Government of India
Ministry of Railways
Research Designs & standards Organisation
Manak Nagar, Lucknow 226011.

No. EL/3.2.12/EC2

MODIFICATION SHEET NO. RDSO/WAM4/83

MOUNTING OF R'5 & RCL RESISTORS
OF BCF-7 BATTERY CHARGERS

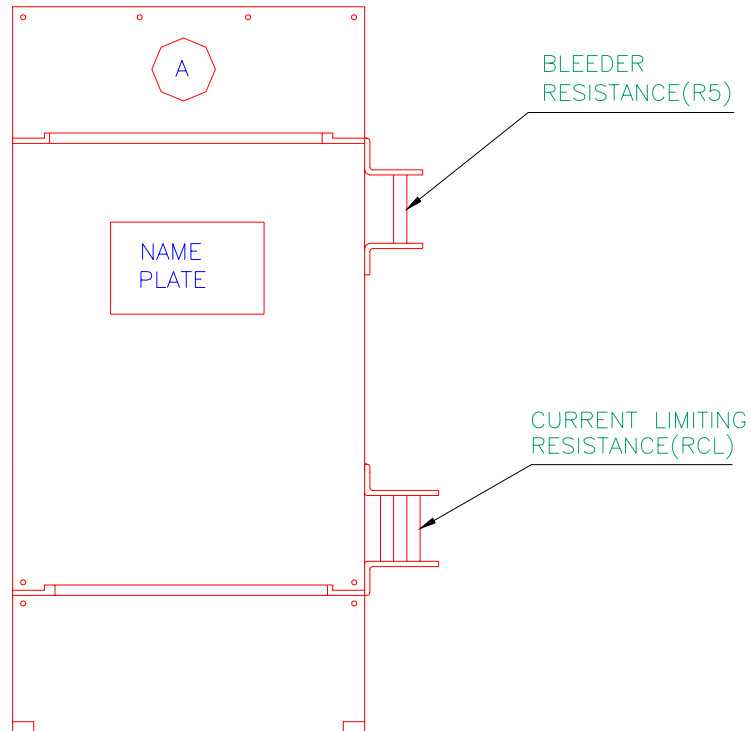
1.1 Railway have reported a number of failures of BCF7 battery chargers mainly due to failures of various components such as resistors, capacitors, transistors etc. On investigations it has been found that high ambient temperature around the components inside the charger is one of the contributory causes. To reduce the ambient temperature of air inside the charger it is proposed to shift the bleeder resistance (R'5) to a location outside the charger.

2.1 Shift bleeder resistor (R'5) presently mounted inside the battery charger to outside the charger and mount it on the side panel of the charger in the similar may as done on BCF6 chargers.

7. **Modification Drawing :** RDSO SK. EL. 3151
